2026 ISP Methodology Consultation – Issues Paper

Submission to AEMO, 22 November 2024

Figure 1: IEA electrolyser capex estimates

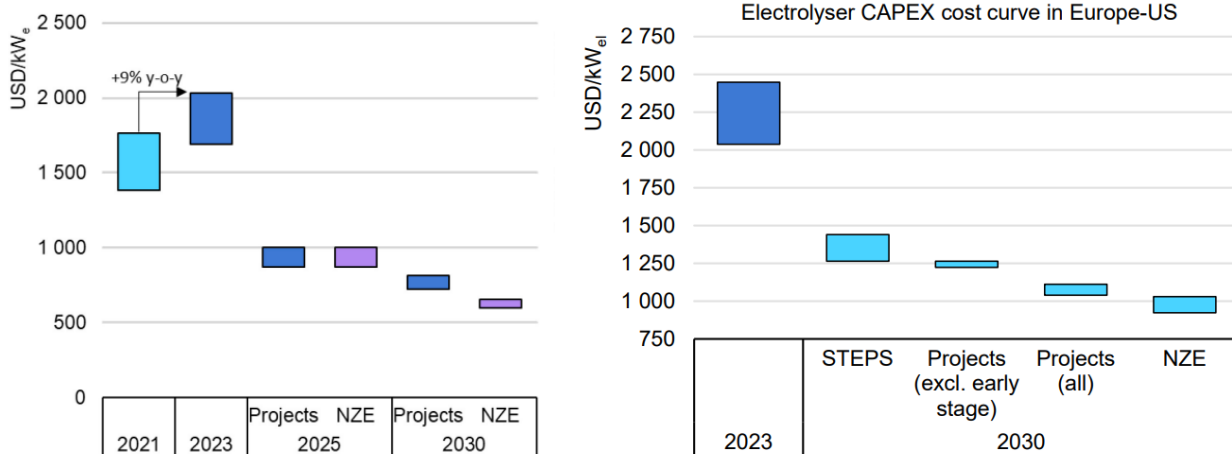
Evidence has emerged that electrolyser capex has been materially underestimated in public estimates such as the CSIRO GenCosts (2023: \$A1,919/kw alkaline), with a key driver the insufficient appreciation of the full scope of system costs.

- Utilities and labour costs are higher for Western manufacturers
- II. IEA: In October 2024 IEA (IEA, 2024) revised 2023 electrolyser and 2030 capex projections revised upward. For the 2023 estimate, *based on newly available data from more advanced projects and to include contingency costs, resulting in an increase of about 20% (BNEF 2024, TNO 2024).*

Figure 2: Ramboll estimates for PEM electrolyser hydrogen production plant CAPEX from estimates of system size 10MW - 1GW

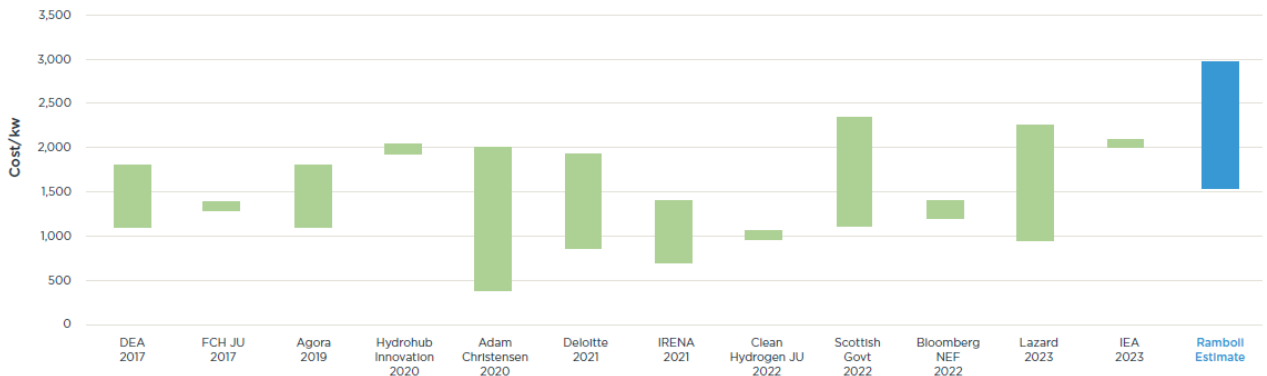
- III. **Ramboll:** in November 2023 Ramboll, a global architecture, engineering, and consultancy company, released a whitepaper on achieving affordable green hydrogen production plants (Ramboll, 2023). Ramboll has worked on more than 30 power-to-X projects across the US and EU and the whitepaper highlights that public estimates of hydrogen projects capex were 2-3x too low and discusses the key driver of this bias. They find that electrolyser stacks represent a small portion of hydrogen project costs, with other components such as BOP, offsites & utilities and construction indirect representing a larger portion of capex.

Figure 3 - Fitzroy REZ Wind Project Footprints – Source: National Map and proponent websites (August 2021)

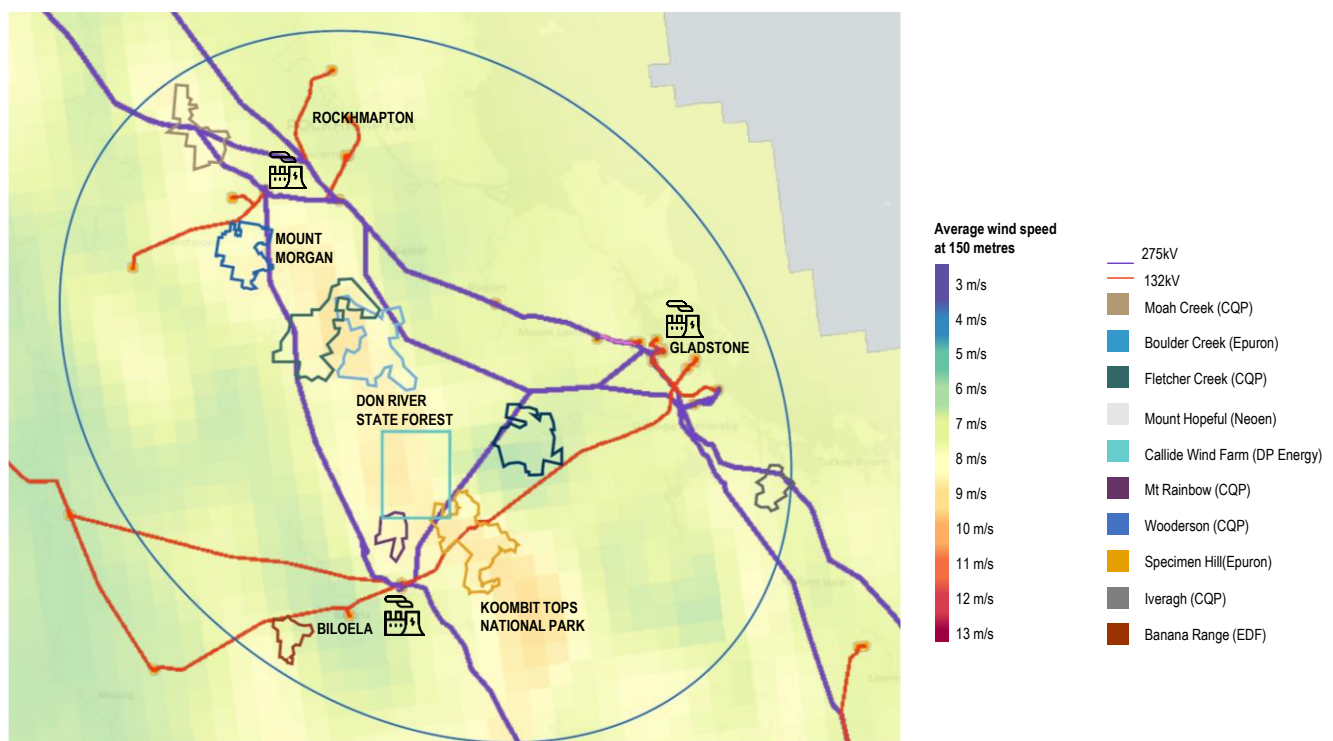
There is uncertainty around the developable capacity and capacity factors of wind resources within REZ due to a range of social, environmental, technical and economic constraints. AEMO should consider adding a validation step for its wind resource quality determination methodology that compares modelled developable resource footprints and capacity against data for proposed projects from subscription services such as <https://renewmap.com.au/>. Proposed project data should also be used to validate AEMO build limits and the level of build limit breach assumed possible by incurring a cost penalty.

REZ close to load centres with sufficient current or planned network capacity may have been fully prospected by developers. Fitzroy REZ is a prime example, as per Figure 3, even in August 2021 proposed wind farm footprints covered practically the entire ridge of potentially developable higher wind speed areas west of Gladstone. Proposed wind project capacity at this time was similar to the build limit of 3,500MW for the Fitzroy REZ and this does not consider that wind project capacity typically declines over the project development cycle. The 3,500MW compares to the 7,550MW of wind assumed to be developed by 2050 under the 2022 ISP Green Energy Exports scenario.
